SERVICE BULLETIN

APPLICABILITY: 2015-2020MY WRX 2.0L DIT Models

NUMBER: 03-78-17R

SUBJECT: Clutch Release Bearing- Design Change

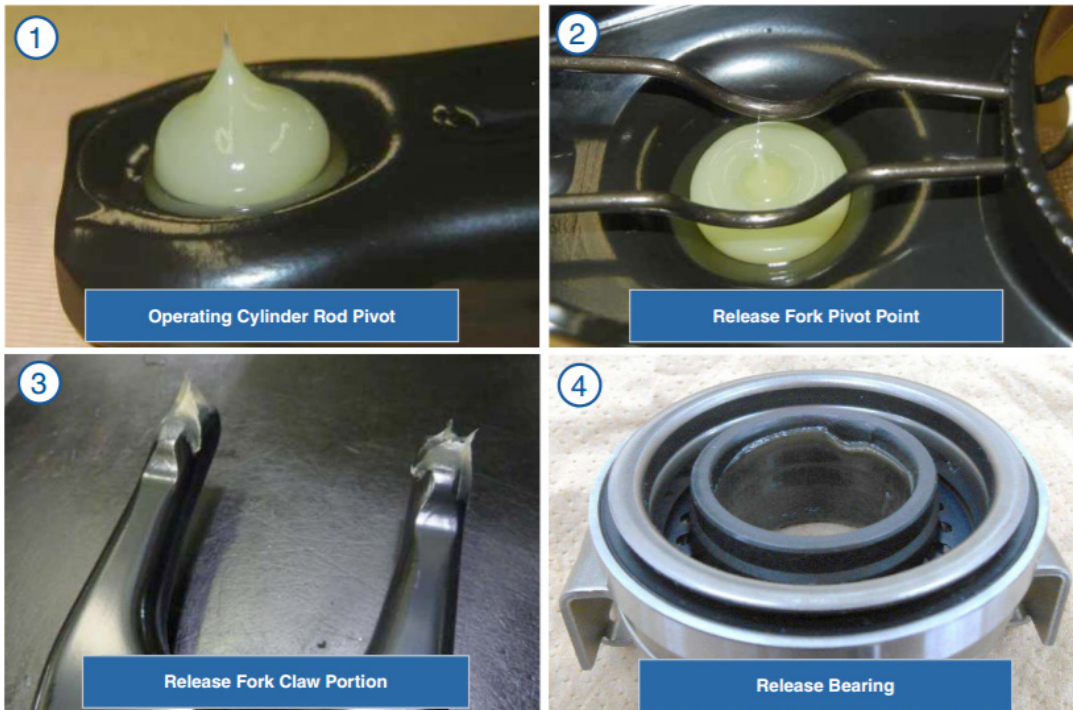
The part number for the new clutch release bearing is: **30502AA160**. The photos below show the differences between the old and new-style parts. The shape of the outer race has been changed.

The new clutch release bearing was incorporated into production starting with VIN **H9824973**.

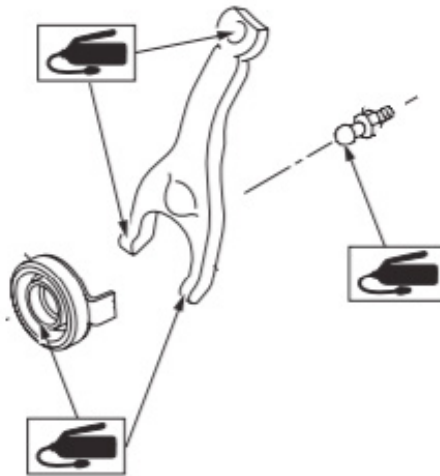
- Always inspect for any excessive or abnormal wear on the release fork pivot point, operating cylinder rod and release lever pivot points, and the pivot ball.
- Always use the proper grease (Nichimoly N-130, Conoco-Philips Multiplex Red #2 or Subaru p.n. 000041000) when lubricating the contact points of the release bearing and related components as specified in the Service Manual and shown below.
